SWIM PROJECT PROFILE		File No. : 224
Regist. No. : Agency No. : BSWM-144	Name : LOOY SWIP	
Region: 12	Province: MAGUINDANAO	Municipality: SOUTH UPI
Present Status: 1. Pre-F/S( ) (2) F/S(1983) (3) D/D(1983)		
Purpose: Major : Irrigation Incidental : IF, FC		
Project Feature:

SWIM PROJECT PROFILE		File No. : 225
Regist. No. : Agency No. : BSWM-145	Name: DALINGAWEN SWIP	
Region: 12	Province: NORTH COTABATO	Municipality: PIKIT
Present Status: 1. Pre-F/S( ) (2) F/S(1983) (3) D/D(1983)		
Purpose: Major : Irrigation Incidental : IF, FC, WM		
Project Feature:

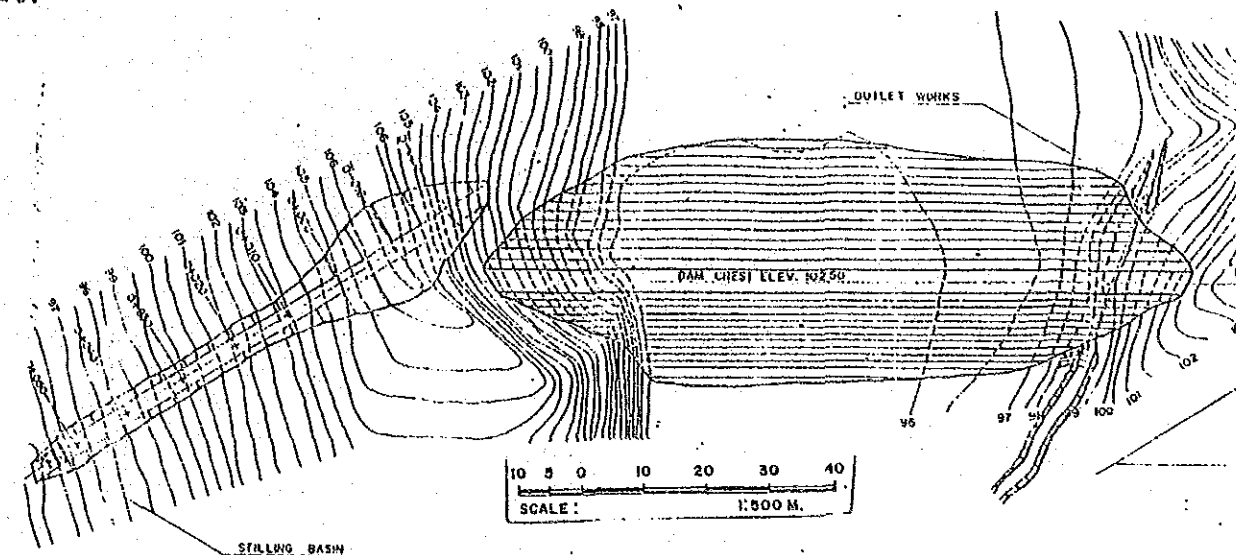
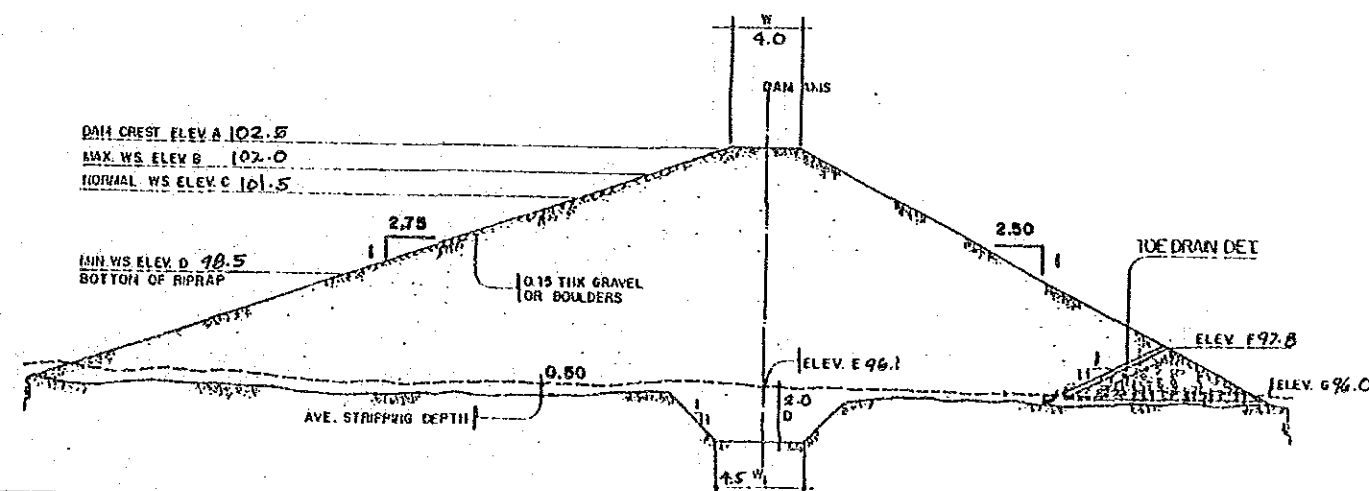
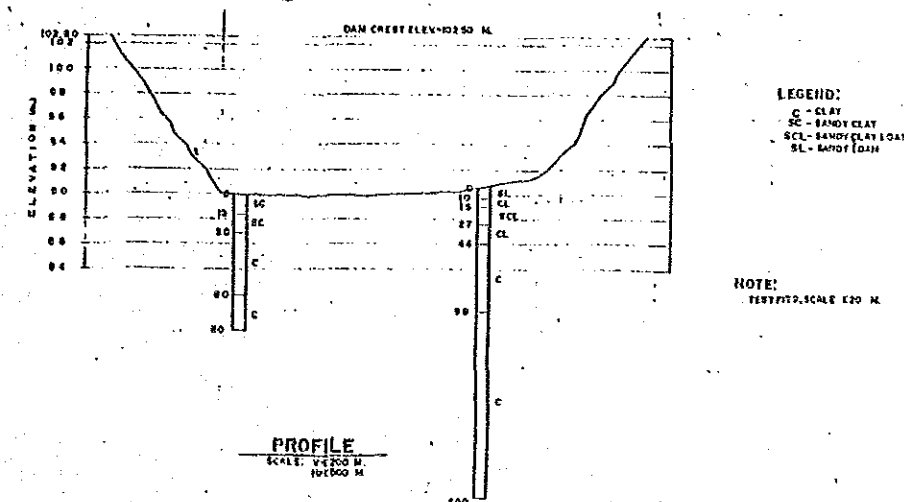
6. Inland Fishery	: Annual Production	: 3 ton/year
Technical Assessment:		
1. Survey and Investigation: Depth of test pit or auger boring is not enough. Bearing capacity and permeability are not measured. Available volume for dam embankment shall be studied before construction.

2. Planning Annual production of inland fishery is over-estimated. Environmental conservation plan is not formulated.		
3. Design Depth of core trench shall be modified during construction. Stability of upstream slope of the dam shall be checked. Freeboard is not enough. Weir shall be provided in the spillway.

Note: Clay blanket with more than 2.0 m depth is piled up on the sand stone and shale. Additional 0.5 m freeboard is necessary.

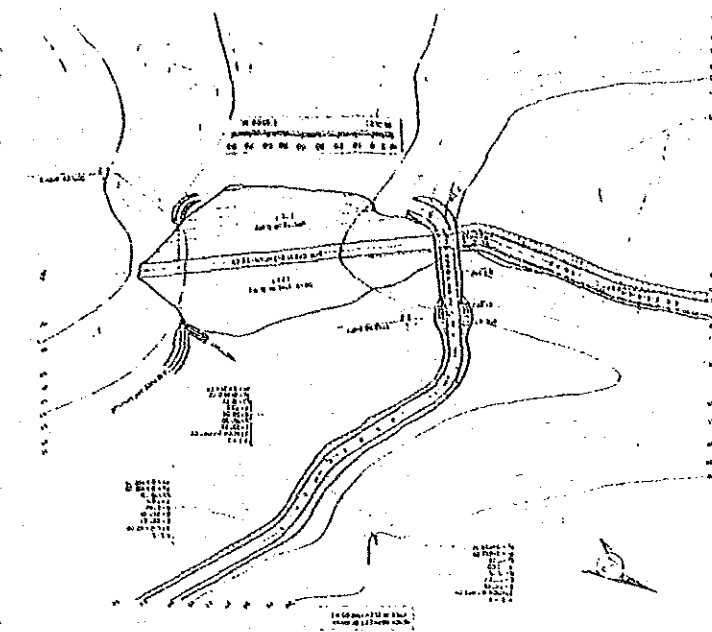
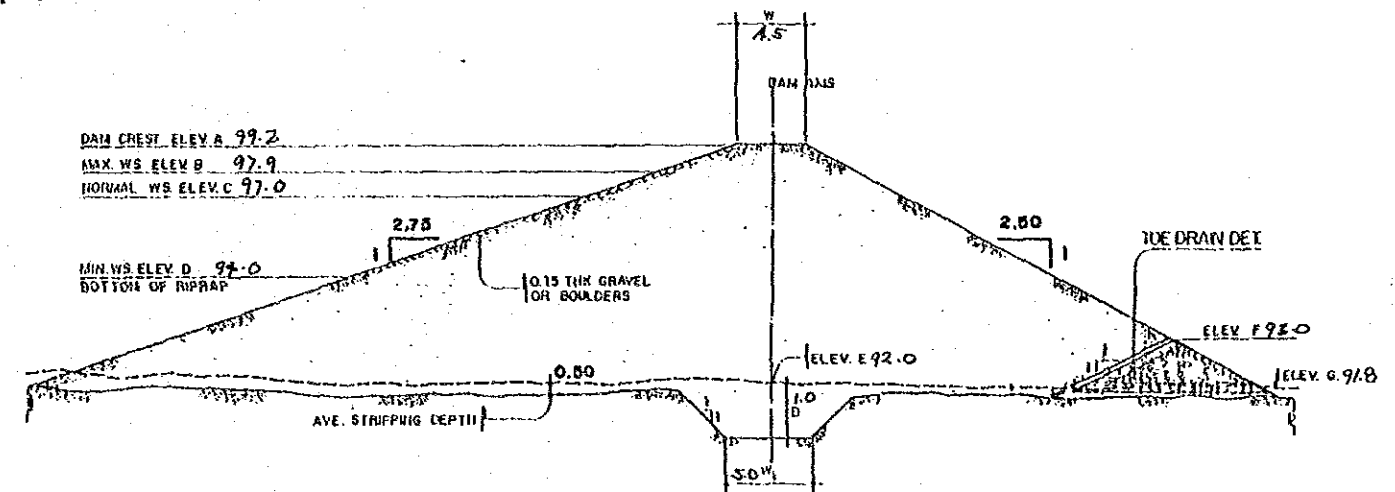
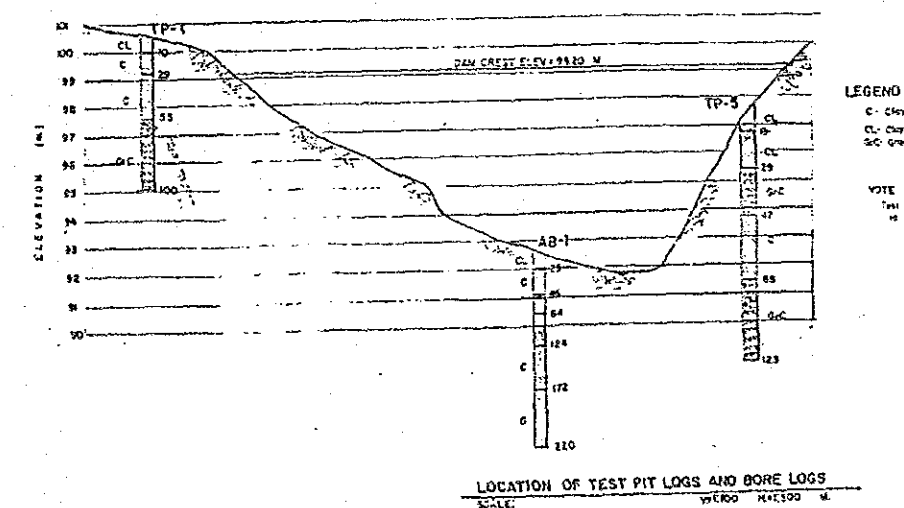
6. Inland Fishery	Annual Production :	10 ton/year
Technical Assessment:		
1. Survey and Investigation: Depth of test pit or auger boring is not enough. Bearing capacity and permeability are not measured. Available volume for dam embankment shall be studied before construction.

2. Planning Environmental conservation plan is not formulated.		
3. Design Depth of core trench shall be modified during construction. Stability of upstream slope of the dam shall be checked. Center line of the spillway shall be shifted to left side. Weir shall be provided in the spillway.

Note: Clay blanket with more than 2.0 m depth is piled up on the sand stone and shale.
